**Re: Responses to Information Request – MVEIRB IR #1
Underground Decline/Exploration Drilling and Metallurgical Pilot Plant Program
MVEIRB File EA01-002**

**Canadian Zinc Corporation
Underground Decline/Exploratory Drilling and Metallurgical Pilot Plant
Environmental Assessments**

Response to MVEIRB Information Request No. 1 (October 18, 2002)**Water Treatment Plan****Underground Decline/Exploratory Drilling and Metallurgical Pilot Plant****Introduction**

Figure 1
Prairie Creek Mine
Underground Decline/Exploratory Drilling and Metallurgical Pilot Plant Developments
Site Discharge Schematic

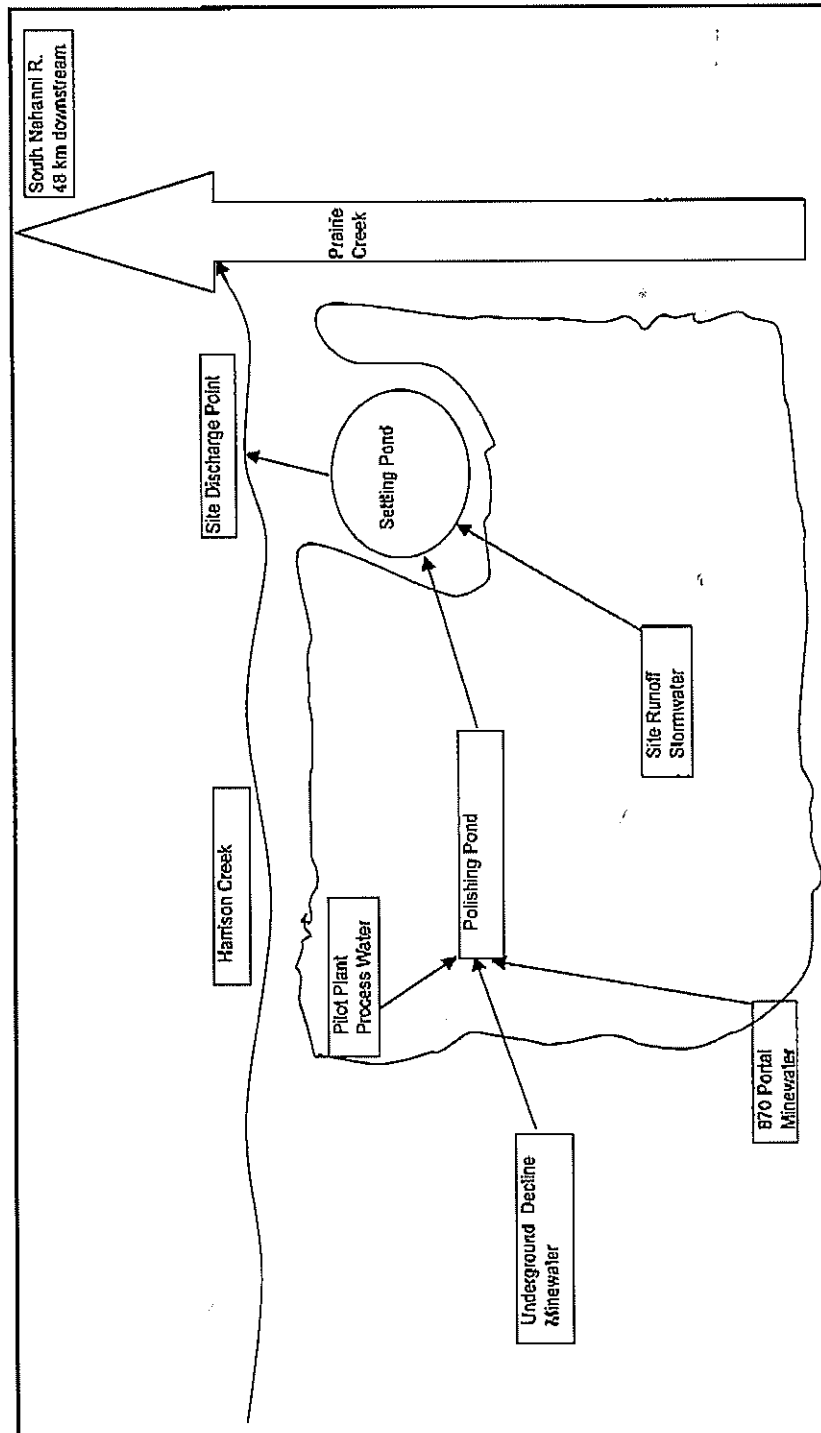
Minewater produced during decline development and underground exploration will be handled through the use of collection sumps and pumps. The underground drainage collection system would consist of a series of excavated collection sumps equipped with pumps located at intervals along the length of the decline, the positioning of which will be determined based on the lift capacity of the pumps and the vertical head between sumps. A final excavated sump would be located underground near the portal entrance where minewater could be treated, if necessary, prior to discharge. Minewater would then be piped down to a polishing pond to be constructed adjacent to the mill prior to release to the site settling pond which then discharges to Harrison Creek. The polishing pond would also serve as a treatment pond for the 870 portal discharge which would be piped to it. * NEW CZN COMMITMENT

The provision for further treating and discharging minewater constitutes an additional mitigation measure should minewater at the sump be determined not to be suitable for discharge to the site settling pond and then to Harrison Creek.

In view of these circumstances, CZN has indicated that it is prepared to proceed with the developments without using the tailings pond. All flows on site will be directed to the site settling pond as the last point of control prior to discharging to the receiving environment. Impacts to water quality will be mitigated by treating flows as necessary using proven technology and discharging from the settling pond to Harrison Creek to meet appropriate discharge limits as set under the Water Licence. *
